SERVICE BULLETIN

APPLICABILITY: 2015-16MY XV Crosstrek Models with Accessory Rear Splash Guard Kit J101CFJ270

NUMBER: 15-191-15

SUBJECT: Corrosion of Attachment Hardware

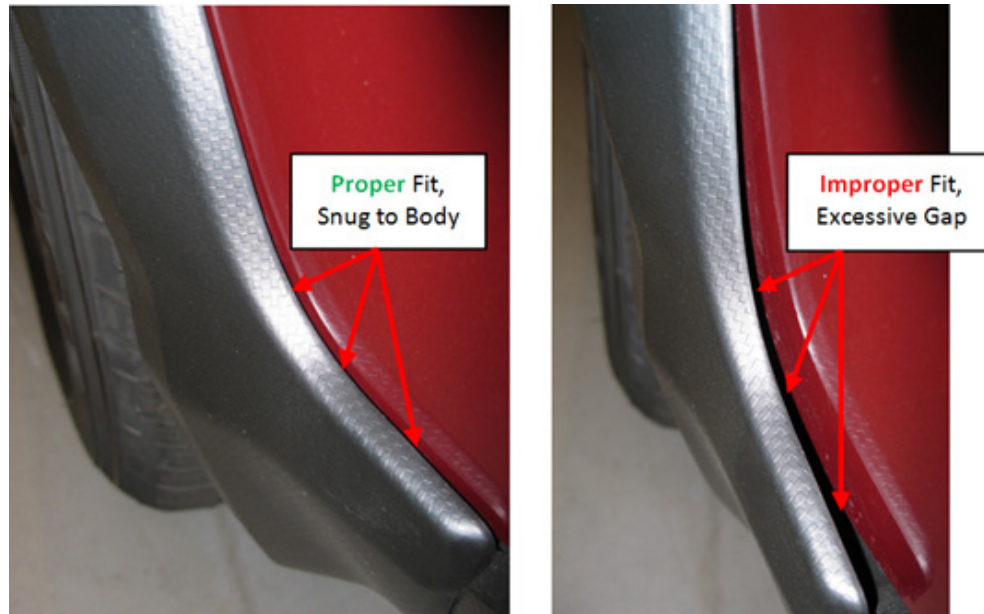
This bulletin announces availability of a replacement attachment hardware kit for the rear splash guards to address customer concerns of poor appearance due to corrosion and / or rusting. Examples of the condition are shown in the photos below.

The part number for the replacement hardware kit (2 screws and 2 washers) is: **SOA008W001**. The new screw and washer will have a glossy black finish as opposed to the original parts which have a more flat or “matte” appearing finish. In the rare case where a replacement “J-Nut” is required, hardware kit, P.N. J101CFJ258 must be ordered.
